State of California
Regional Water Quality Control Board
San Diego Region

**SUPPLEMENTAL
EXECUTIVE OFFICER SUMMARY REPORT
June 8, 2005**

SUBJECT: Section 401 Water Quality Certification: City of San Diego, Fashion Valley Road River Crossing Repair, San Diego River. Discussion of impacts to water quality and beneficial uses and alternatives to avoid and minimize impacts. (*Michael Porter*)

Subject: Fashion Valley Road River Crossing Repair Project (File No. 05C-030)

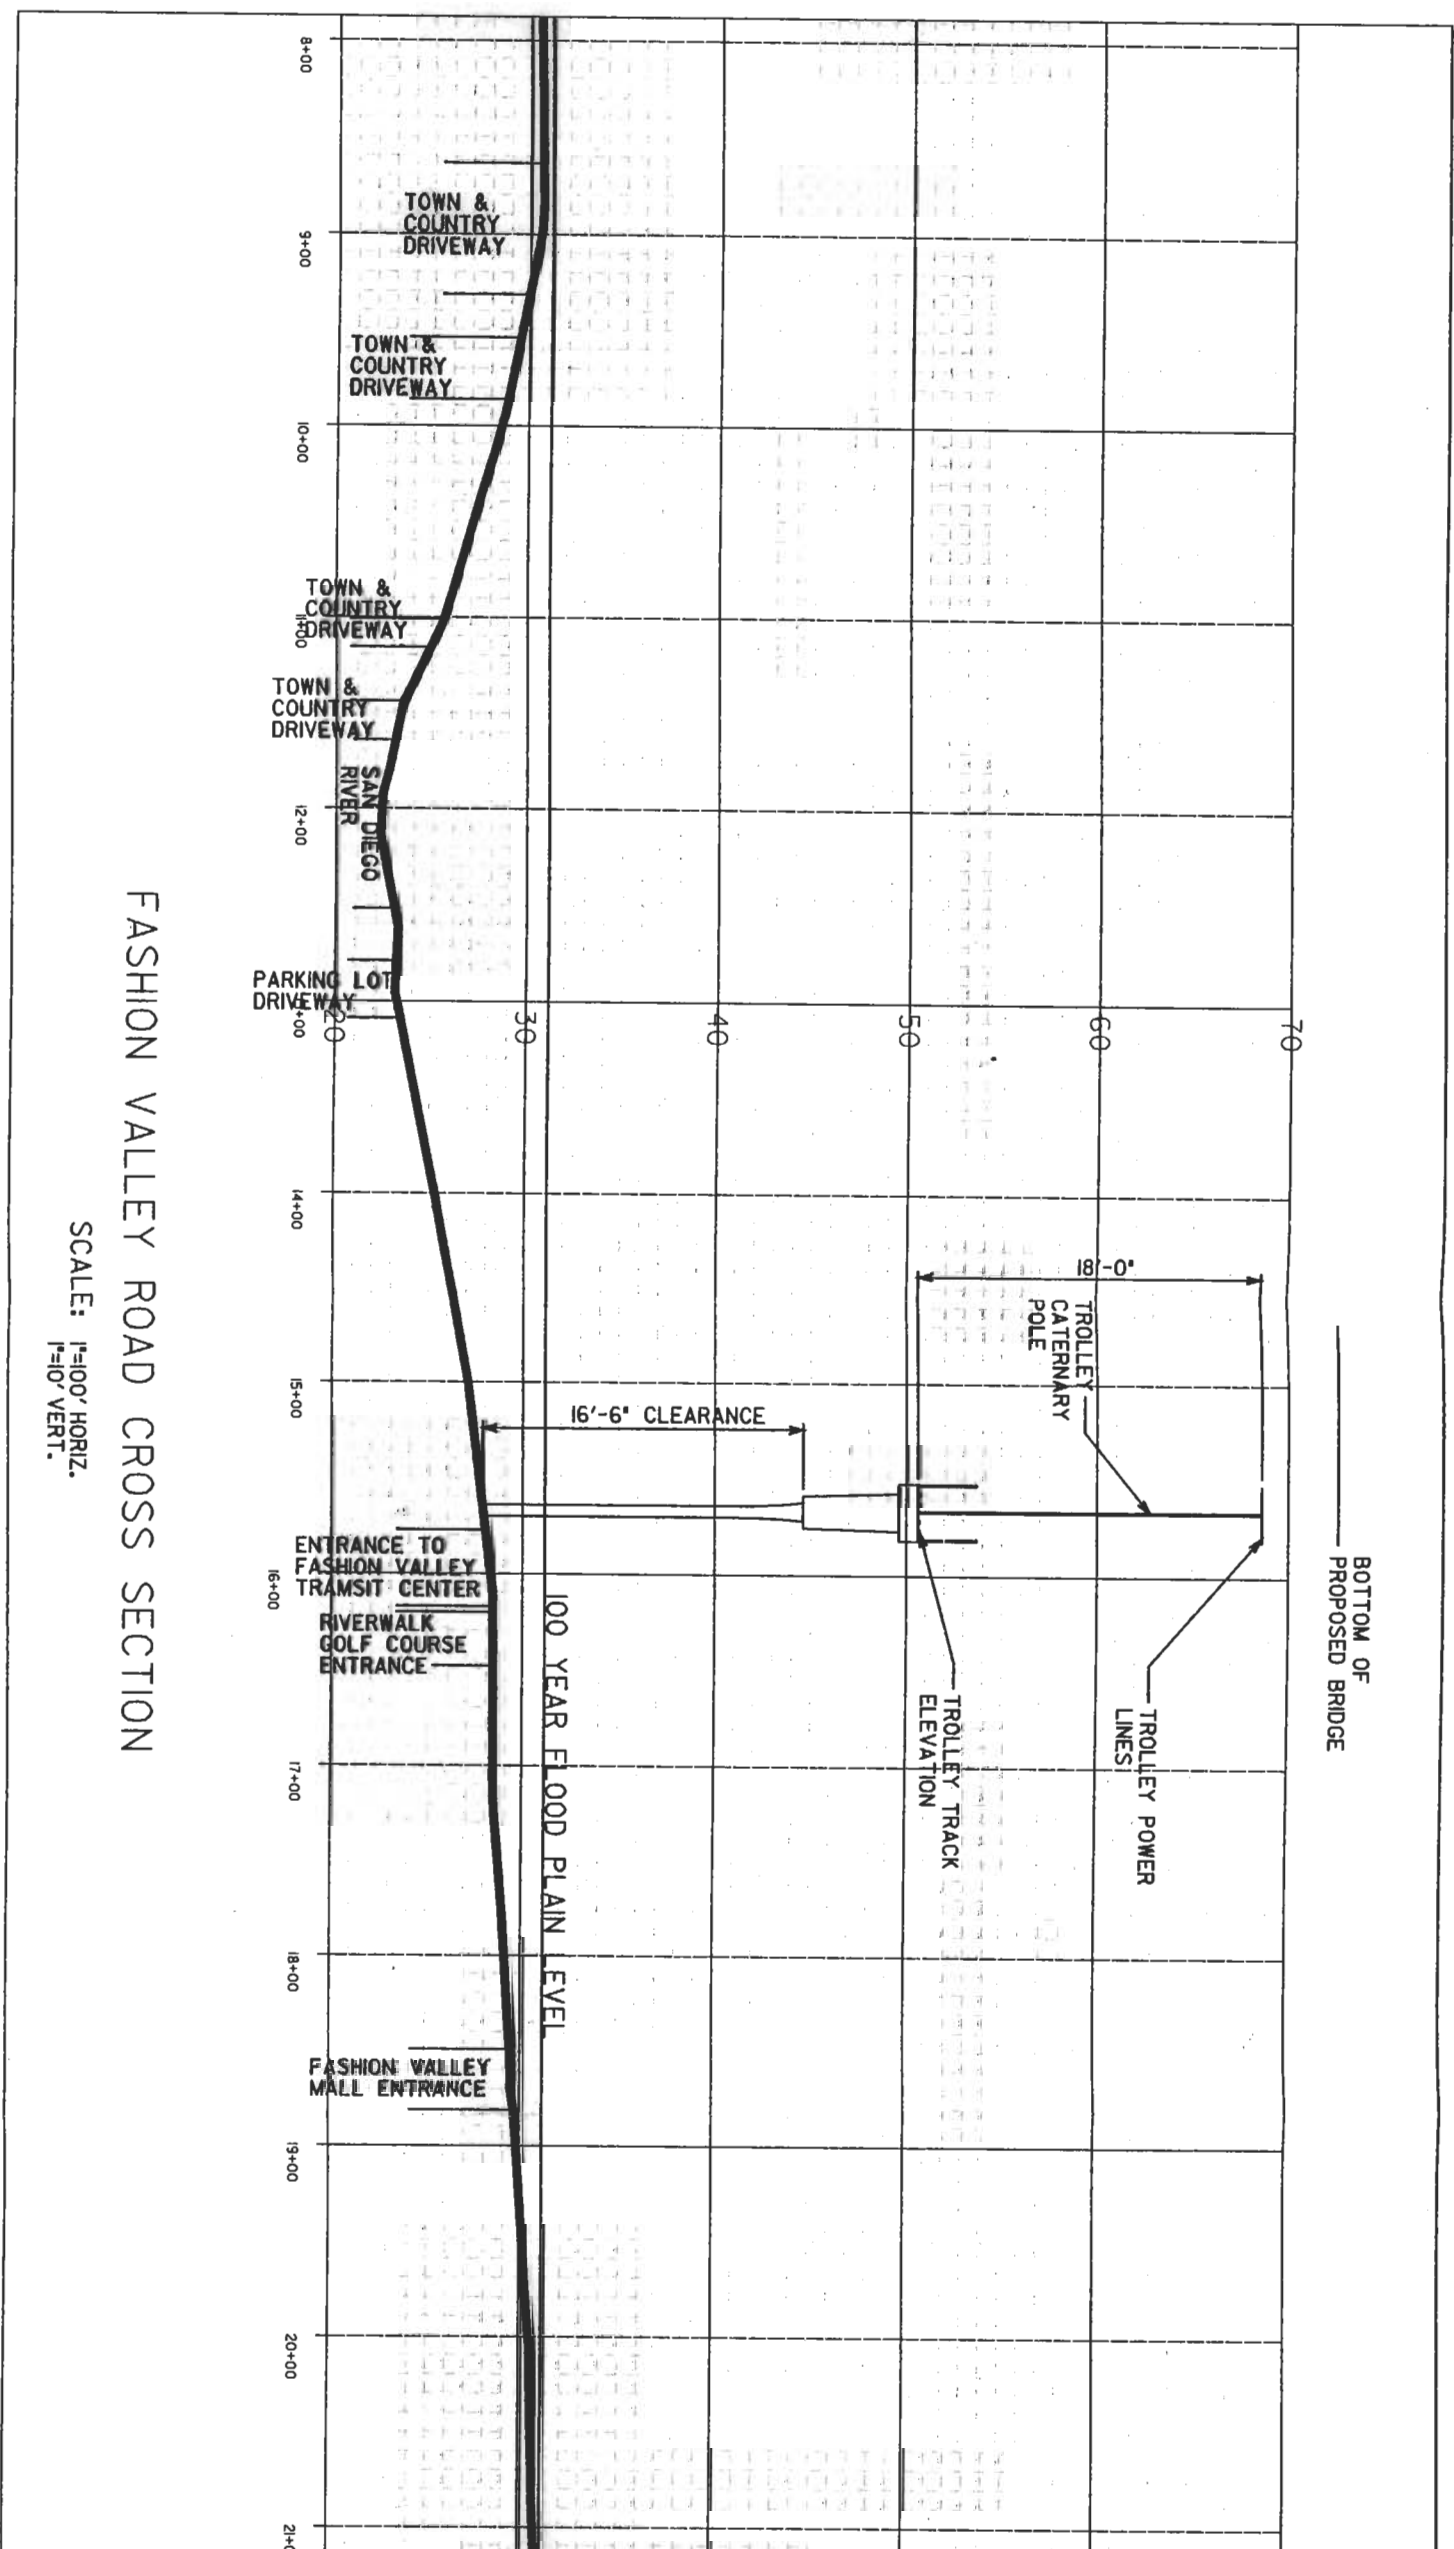
In order to meet all of these requirements, the bottom elevation of a bridge would have to be approximately 5.5 feet higher than the existing road elevation. This elevation would be in conflict with the existing trolley bridge. Avoiding the existing trolley bridge and the trolley when it is moving over the tracks, would then require a much taller structure. An all weather bridge would be about 44.5 feet above the existing road. Attached is cross section of the road showing the 100-year base flood elevation, trolley, and horizontal line representing such a bridge (Attachment 6).

- A bridge 44.5 feet higher than the existing road will eliminate access to businesses in the area.
- Such a bridge also will eliminate access to the Metropolitan Transit System station, which generates approximately 50-60 bus trips per day (due to the collapsed crossing, buses are having to be rerouted which is resulting in additional costs for MTS and inconvenience for transit riders).

- At a maximum grade of 8% slope, it would be a challenge for the bridge to tie in to existing roads (i.e. Friars Road and Camino Del Rio North). See attached detail (Attachment 6).
